ADDENDUM NO. 5

Reference: Student Activity Center Addition to the Stromberg Athletic Complex
Weber State University – Ogden, Utah
DFCM Project No. 12031810

ADDENDUM #05

Project: WSU Student Activity Center-Stromberg Addition

Sheet S002

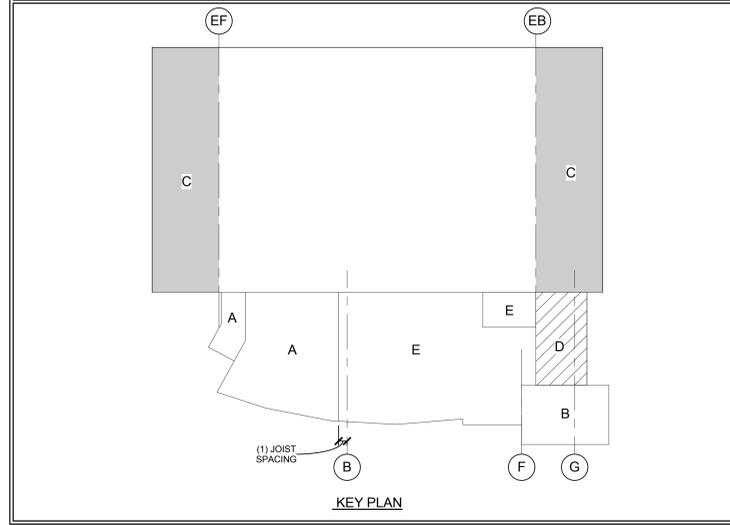
-Reinforcing has been revised for the FC2, FC4, and FC5 in the footing schedule.

Job # 12475
CAD File
Drawn BLP Checked JLA
Date 10.03.2012
Owner # DFCM #12031810
AREA C FOOTING AND FOUNDATION PLAN

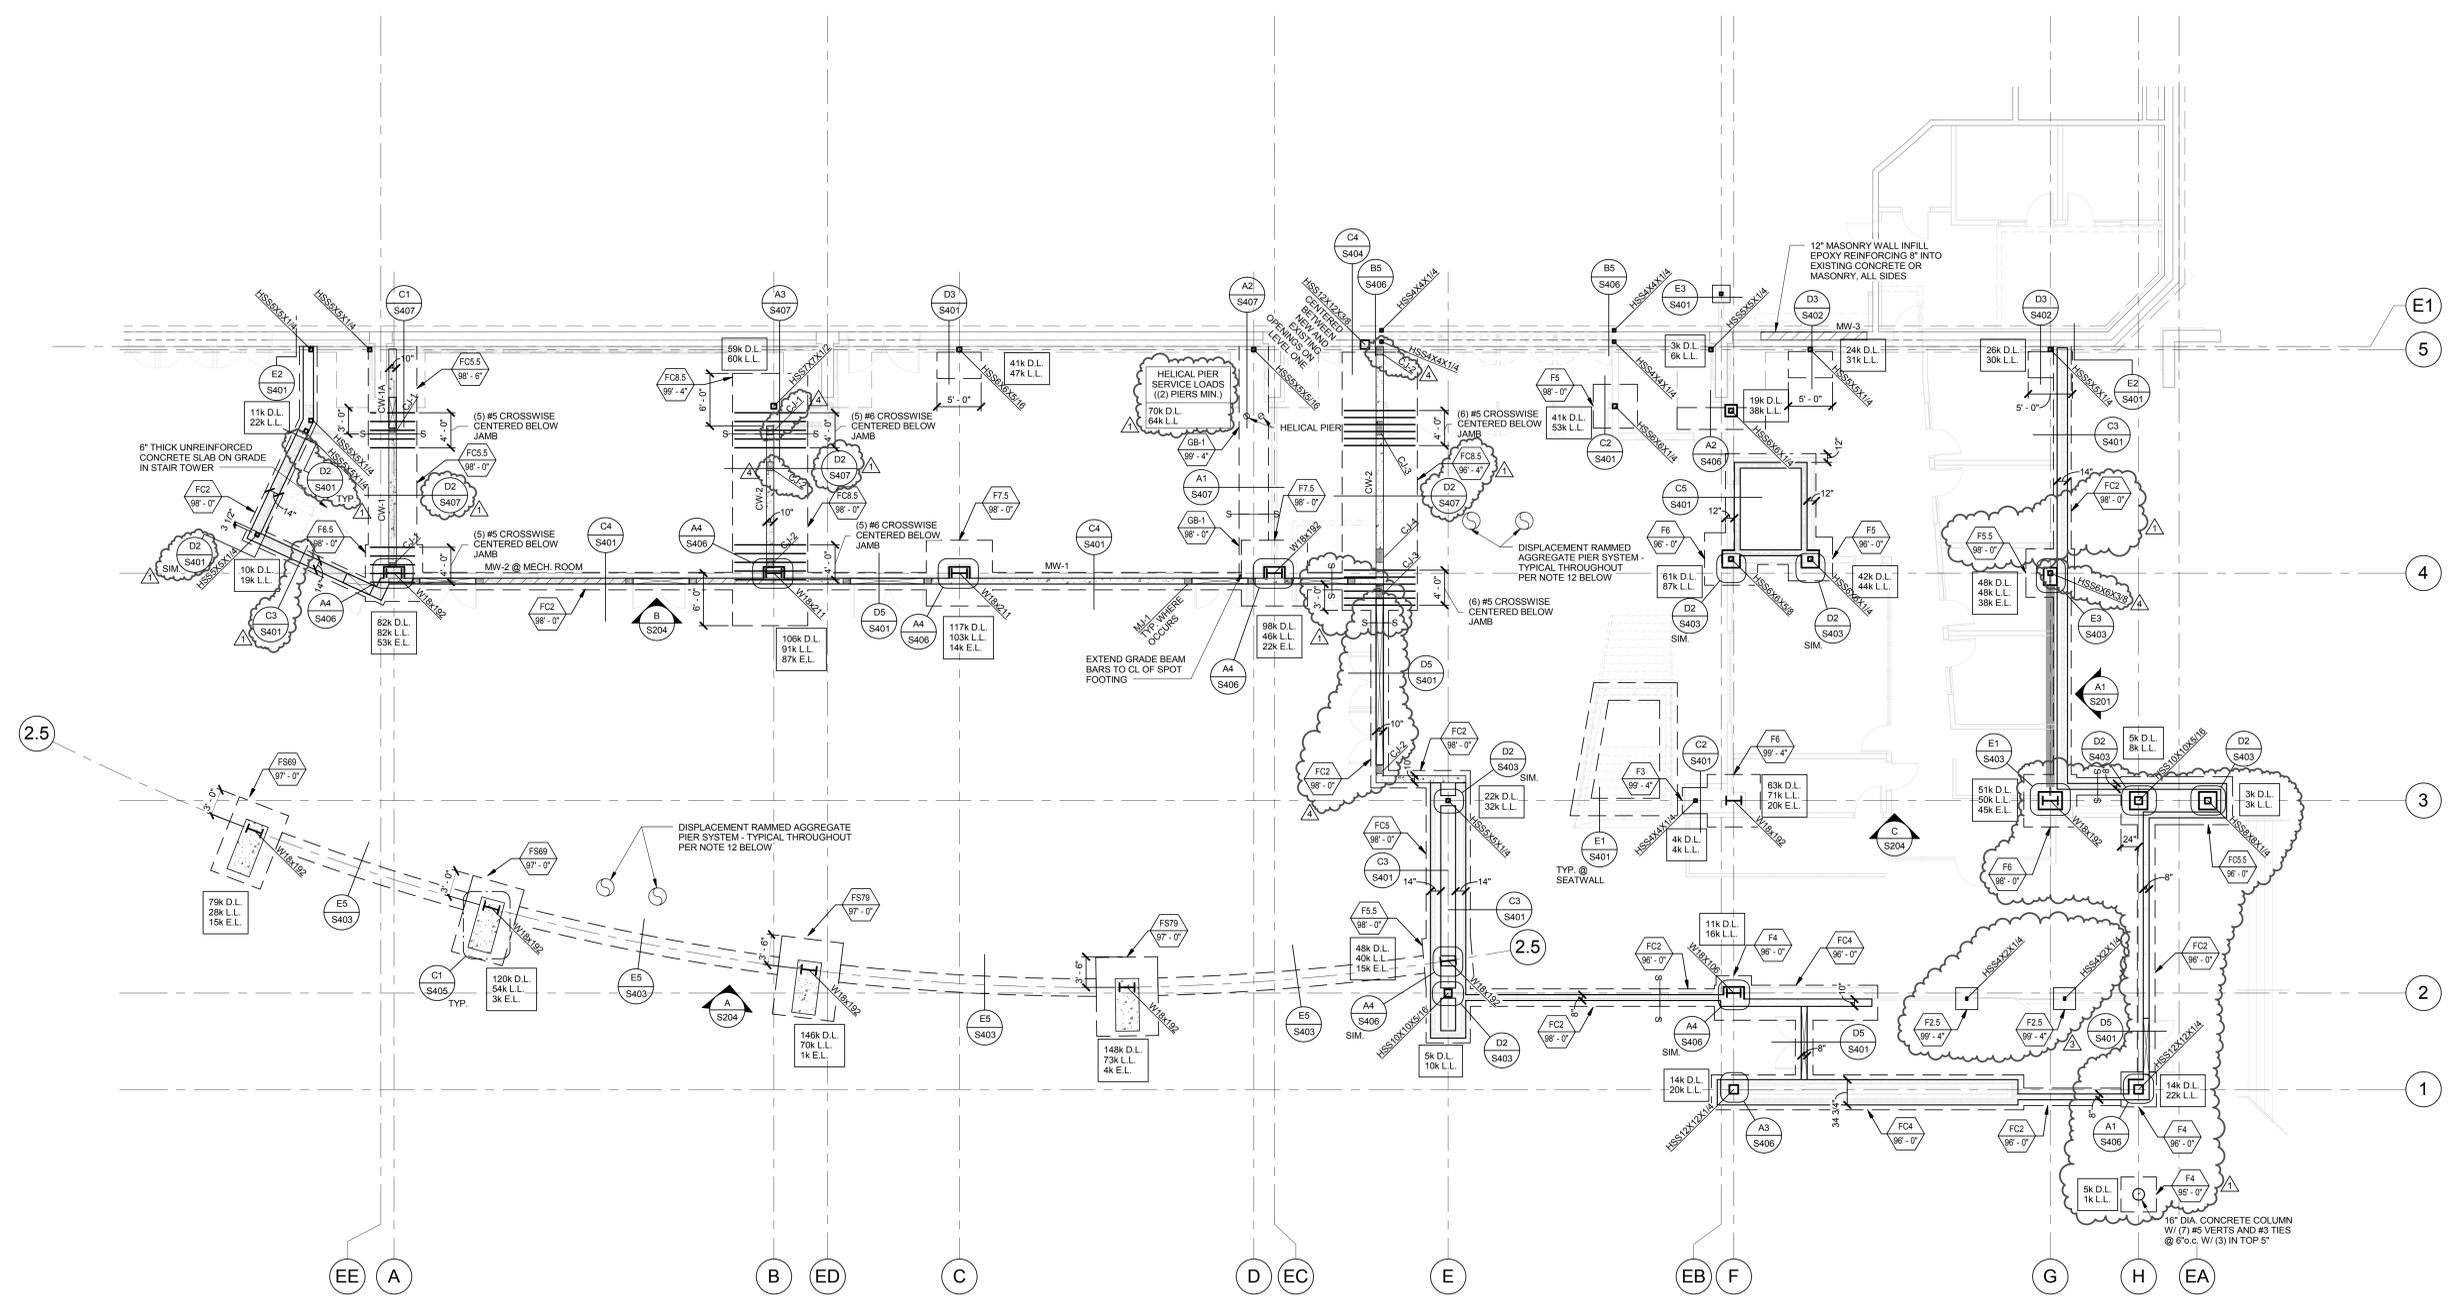
-A column size has been added for the column at 4-G.
-The errant footing callout at 2.5-EC has been removed from the plans.
-The opening for the entry doors in the concrete wall on gridline EC.5 has been revised. The small piers between the openings have been deleted.
-Concrete jamb callouts have been revised at the three concrete walls on gridlines A, B, and D.5.

AREA C FRAMING PLAN

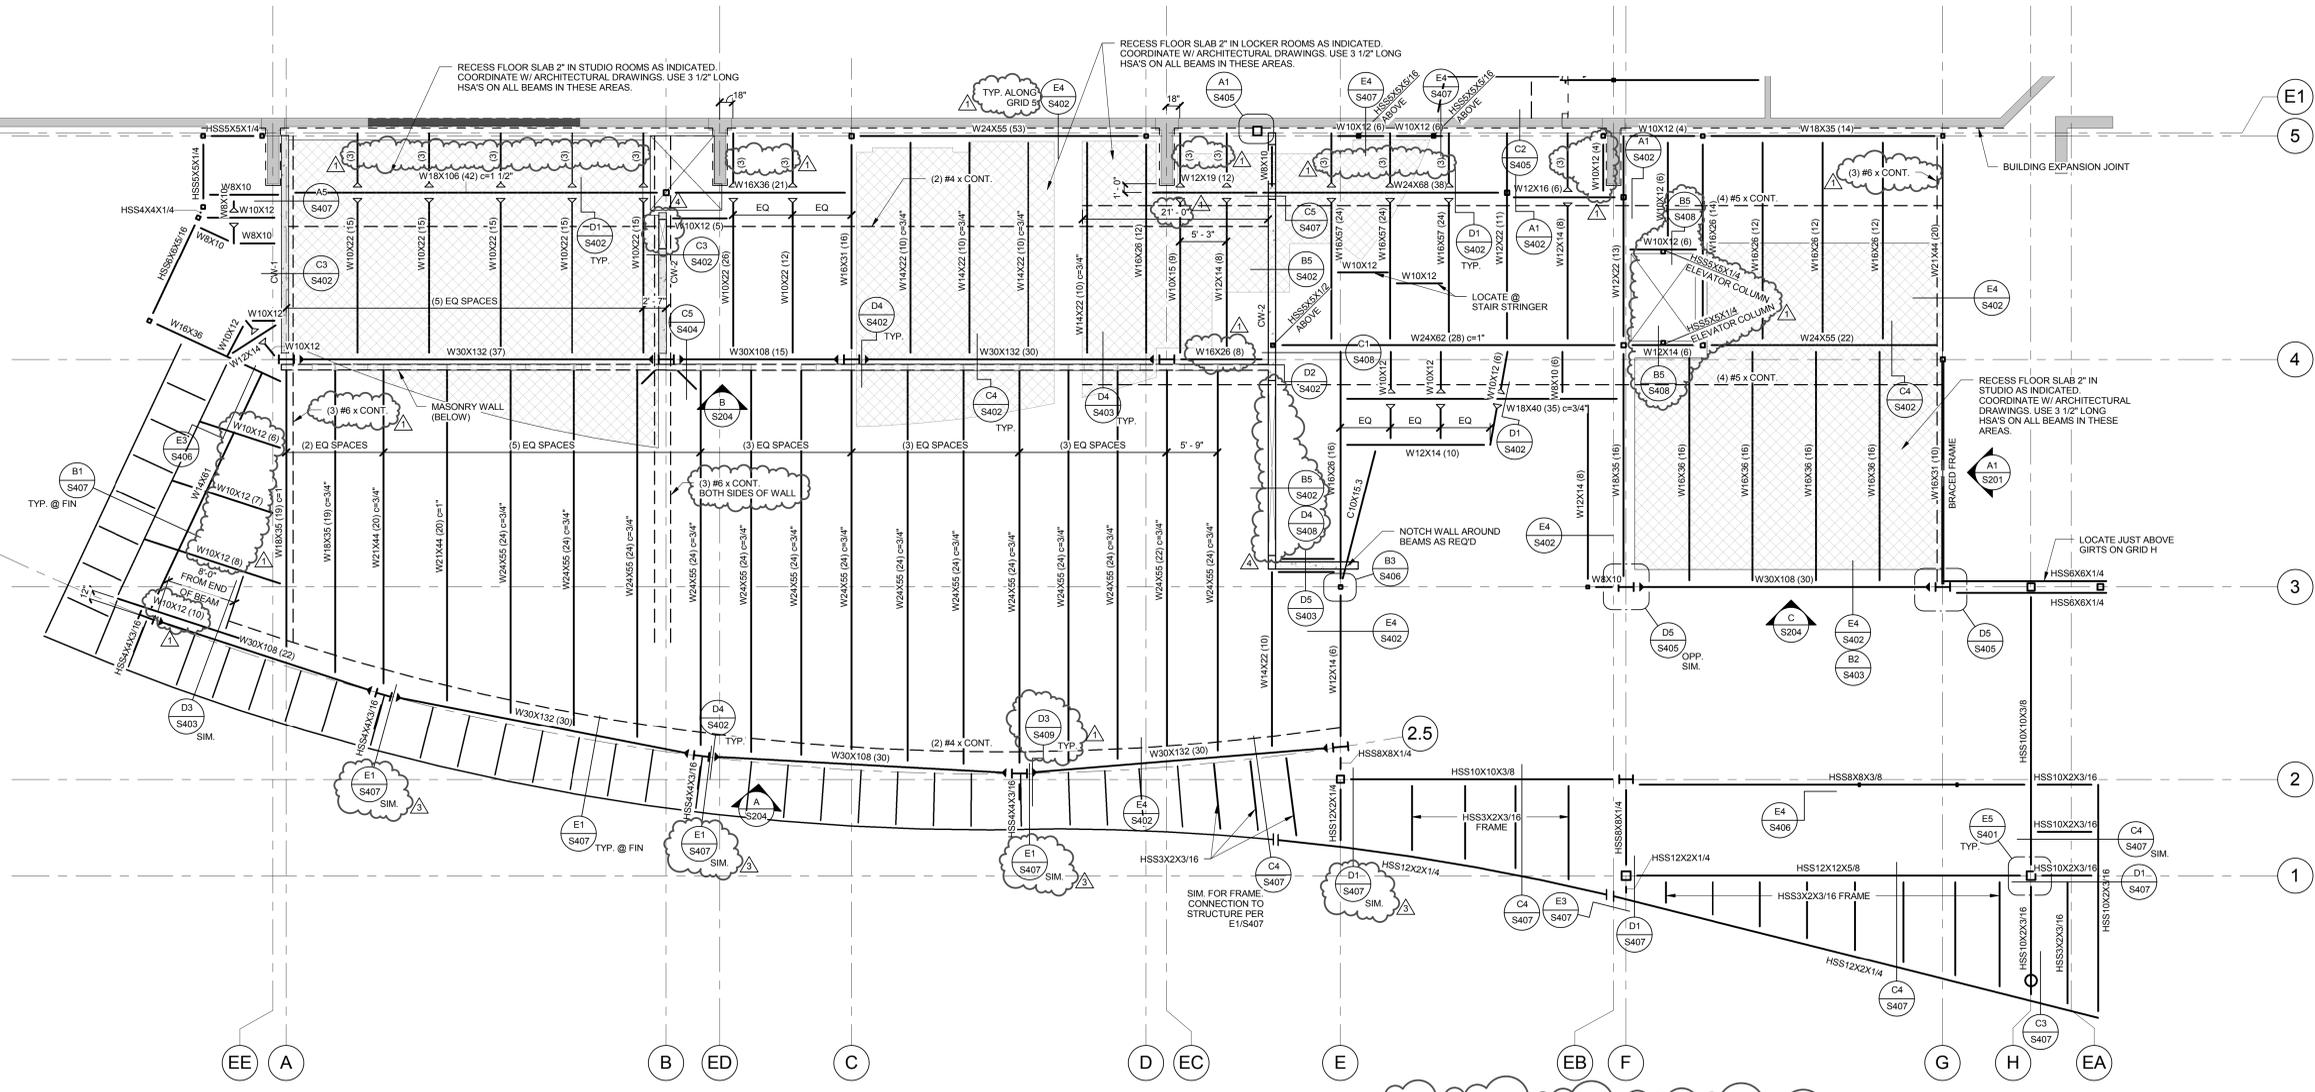
-Rebar has been added and detail cuts have been added to the plan B/S133.
-Dowels have been added to the columns in the plan A/S133 and the stringer design forces have been revised.

ROOF FRAMING PLAN - AREA C
SCALE: 1/8" = 1'-0"

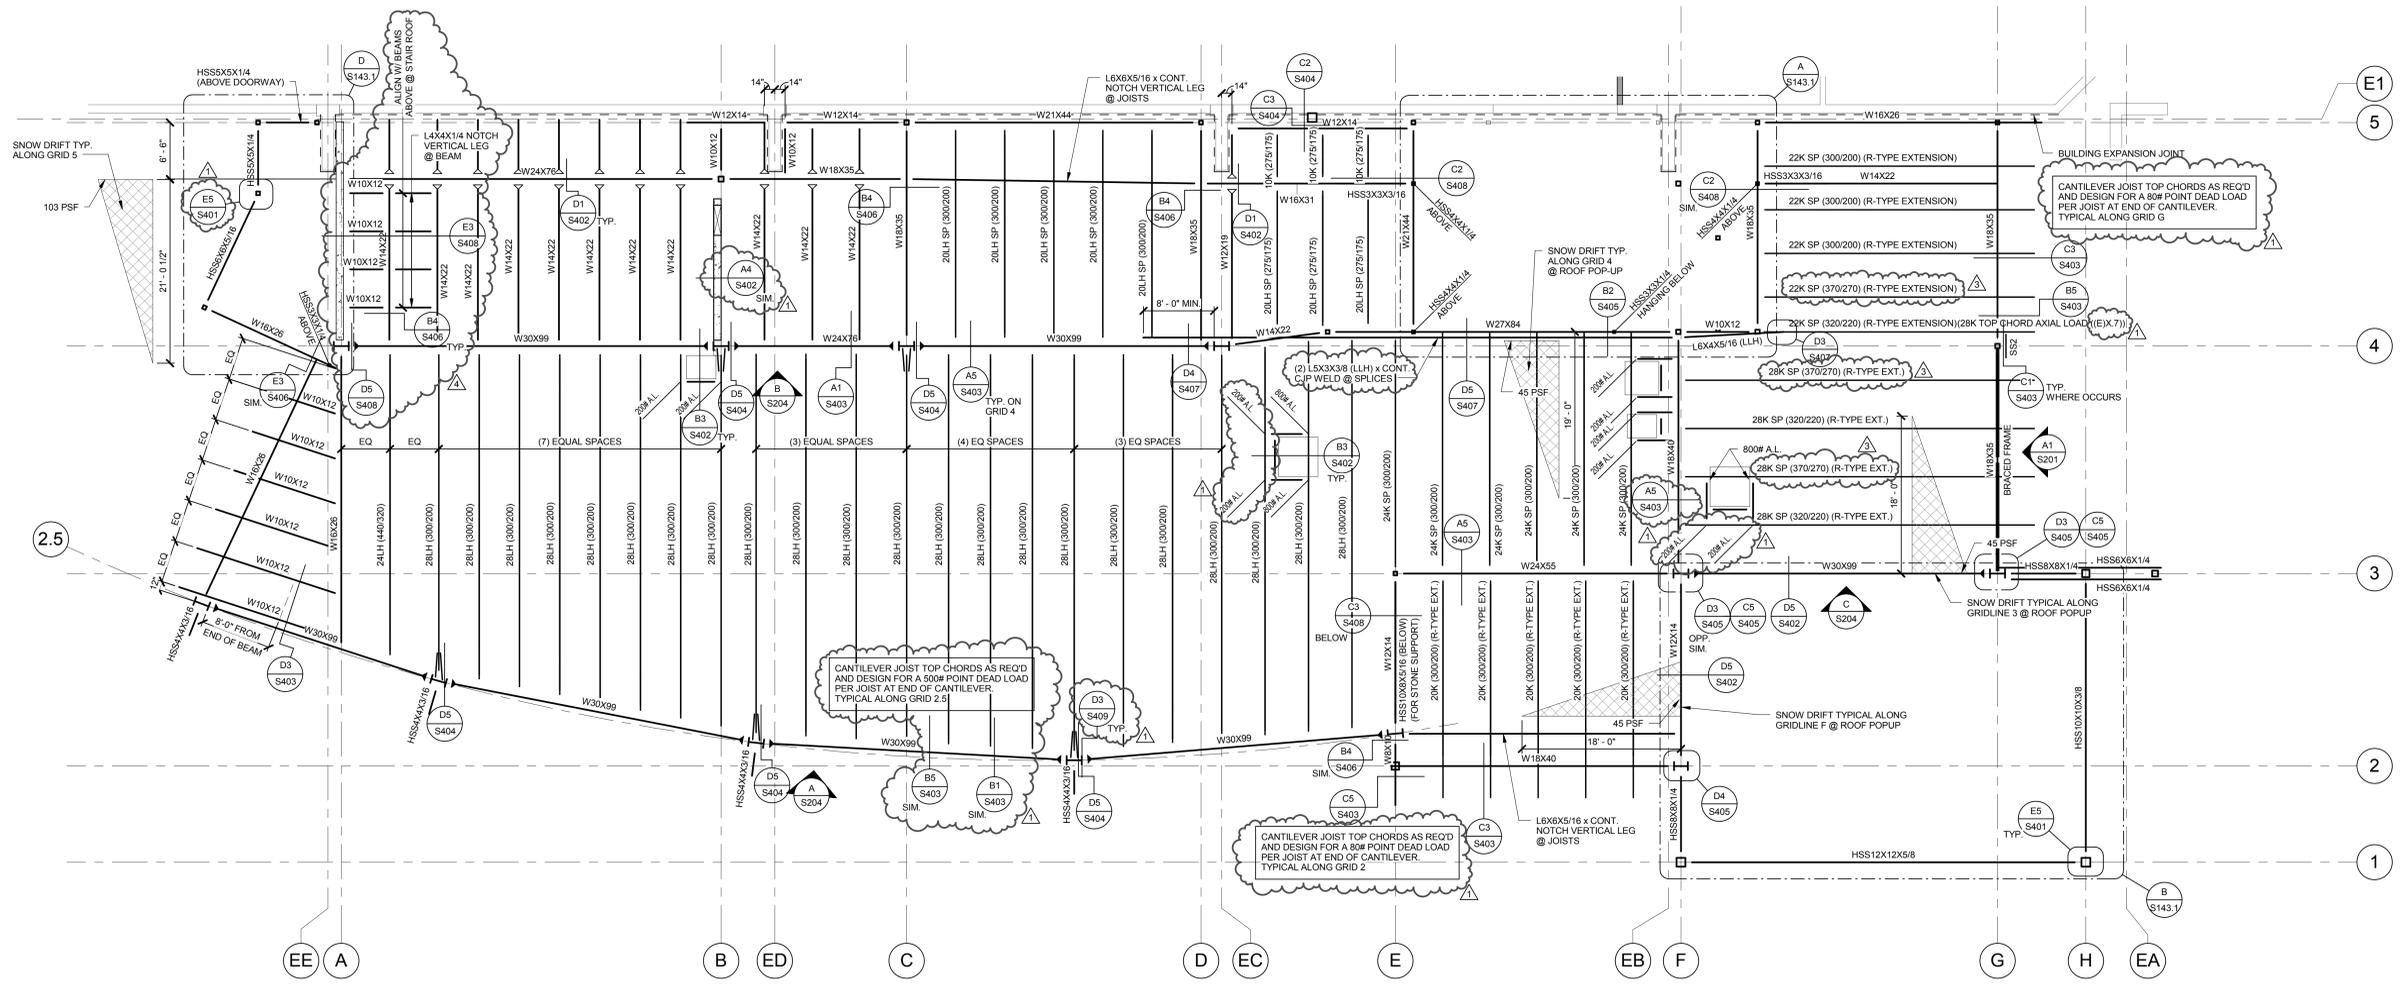
-Framing has been added along gridline A between 4 and 5.

AREA C HIGH ROOF
FRAMING PLAN

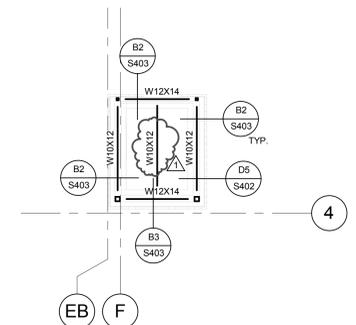
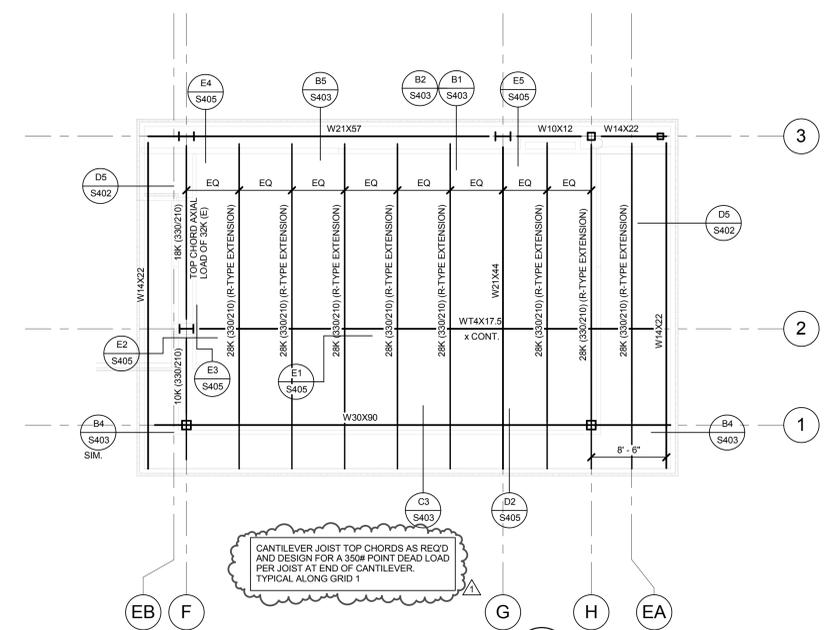
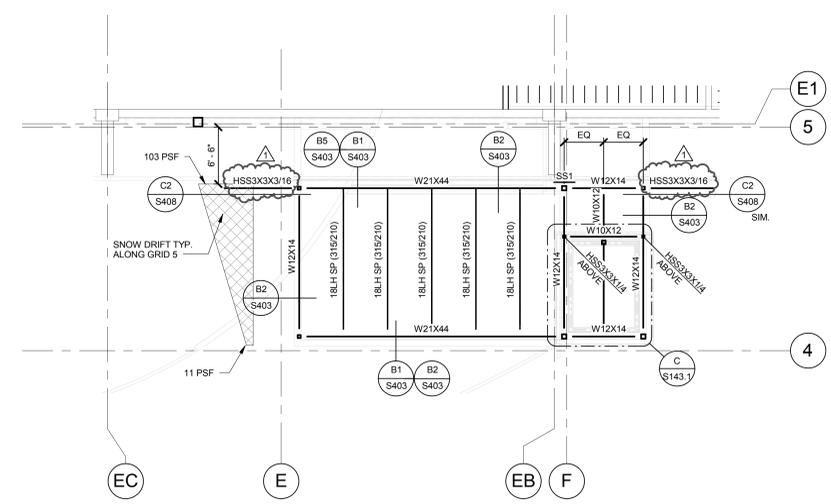
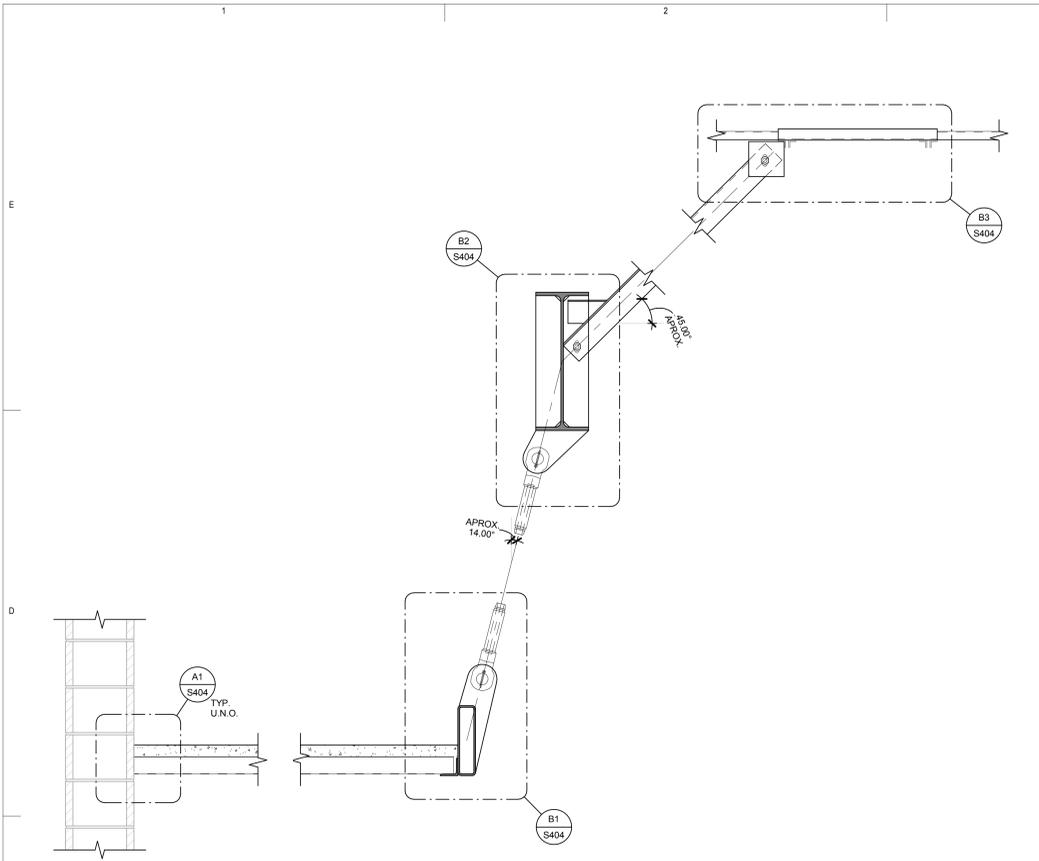
-Detail cuts have been added to framing plan D/S143.1.

D5
S202

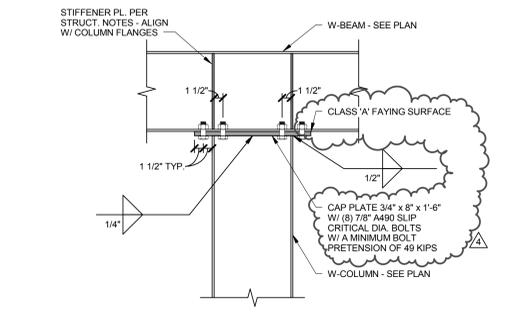
-Details D5 and C5 have been revised to indicate the requirement for slip critical bolts.
